**A Review of
"Economic Feasibility of the Proposed 138 kV
Transmission Lines in the Railbelt"**

Report AN-90-1

February 14, 1990

This report reviews the *"Economic Feasibility of the Proposed 138 kV Transmission Lines in the Railbelt"* prepared by Decision Focus Inc. (DFI) for the Railbelt utilities. A review was done of most, but not all, of the benefit categories for the proposed 138 kV line between Anchorage and Kenai. Because of time constraints and the large number of areas of dispute with the Kenai-Anchorage analysis, a less thorough review of the Healy-Fairbanks line was completed. A summary of the conclusions of the Healy-Fairbanks line review is presented here, but detailed support for the conclusions is not provided.

Figure 1 - Changes to Kenai-Anchorage Benefit Estimate due to 4 Major Method Errors. No other disputes are quantified in the displayed benefit adjustments.

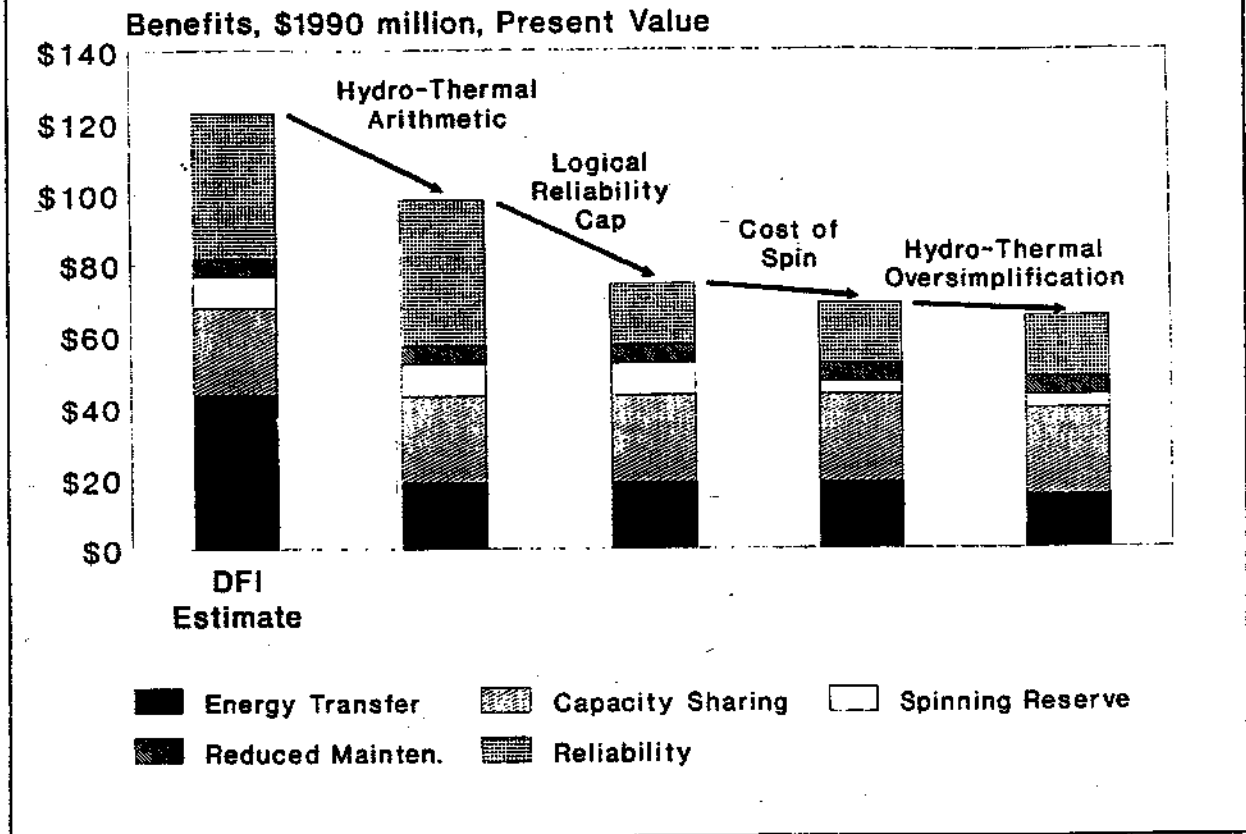
Figure 1 summarizes the magnitudes of 4 major method errors that were found in the DFI Kenai-Anchorage Intertie analysis:

- A computation error was found in the calculation of the hydro-thermal coordination benefits of the new intertie.⁴ DFI has agreed to the existence of the error. The error overstates the Energy Transfer benefits of the new intertie by \$25 million, present value.

- The existing intertie causes power outages when it fails while transferring energy between Anchorage and Kenai. The study claims that these power outages cost customers \$32 - \$50 million, which will be avoided if a new intertie is built. However, the analysis fails to recognize that these outage costs can also be avoided without the construction of a new intertie by giving up the energy transfers that cause the outages. These transfers are only worth \$17 million according to DFI's analysis. The \$17 million transfer benefit sets a logical cap on the reliability benefits of the new intertie. This cap lowers the reliability benefit estimate of the new intertie by \$24 million.

- An incorrect formula for computing the cost of spinning reserve overstates the benefits of increased access to Bradley Lake spinning reserve by \$5.3 million.

- An unnecessary simplification of the hydro-thermal benefit calculation overstates the hydro-thermal benefits of the new intertie by \$3.7 million.

Figure 2 - Two Different Hydro-Thermal Coordination Regimes

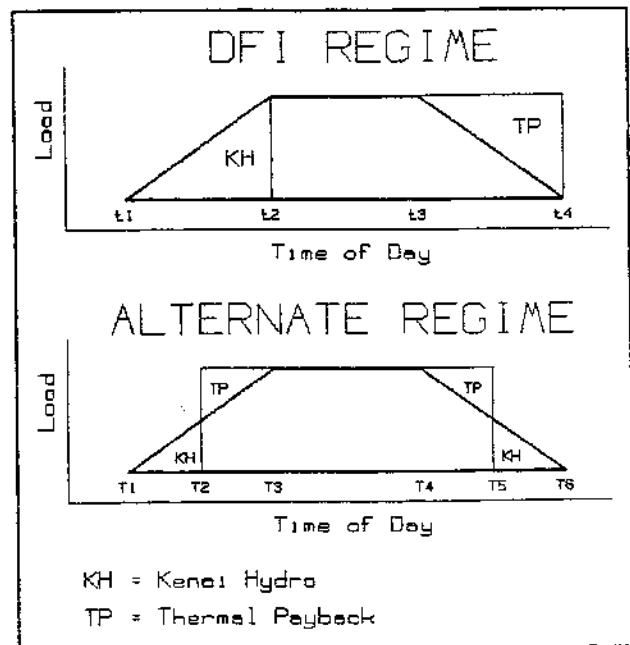
We also believe that the hydro-thermal coordination regime modeled by DFI is a sub-optimal one. A simplified example of DFI's hydro-thermal scheme is graphically depicted in the top part of Figure 2. The figure is meant to show the simplified operating regime of one particular Anchorage thermal unit. Absent hydro-thermal coordination, the unit would turn on at time t1 and its loading would increase to follow the load until it reached maximum loading at time t2. It would remain at maximum loading until time t3 when it once again becomes the

With the type of hydro-thermal coordination modeled by DFI, turning on the thermal unit is delayed until time t_2 . Between t_1 and t_2 , Kenai hydro energy is imported over the intertie to meet the (Load + Spin) requirements in Anchorage. The thermal unit is started at t_2 when it can be fully loaded, and imports are ceased. At time t_3 , when the thermal unit would normally start unloading, its output is maintained at full load. The power in excess of Anchorage (Load + Spin) requirements is exported back to Kenai to reimburse for the previous imports.

An alternative hydro-thermal coordination regime is shown in the lower half of Figure 1. This method achieves the same objective as the DFI regime: it allows all energy produced by the thermal unit to be produced while operating at full load. However, the alternative method requires less energy transfer over the intertie, and it reduces the peak demand on the intertie for the purposes of reshaping. In doing so, it reduces transmission losses relative to the DFI method, and it reduces the periods when the reshaping requirements exceed the capacity of the intertie.

The alternative method involves importing Kenai energy when the thermal unit would otherwise be at low loadings and paying that energy back when the thermal unit would otherwise be at high loadings ("otherwise" meaning absent hydro-thermal coordination). The figure shows the Kenai import and thermal payback periods for this type of hydro-thermal regime applied to the simple example.

Had this regime been modeled when calculating the increased hydro-thermal benefits of the new intertie, the new intertie's benefits would have been less. With such a regime, the capacity constraint of the existing intertie would rarely be a problem. Further, the higher losses of the existing intertie would be less of a problem, since the average transfer required to perform the reshaping is less with this regime.
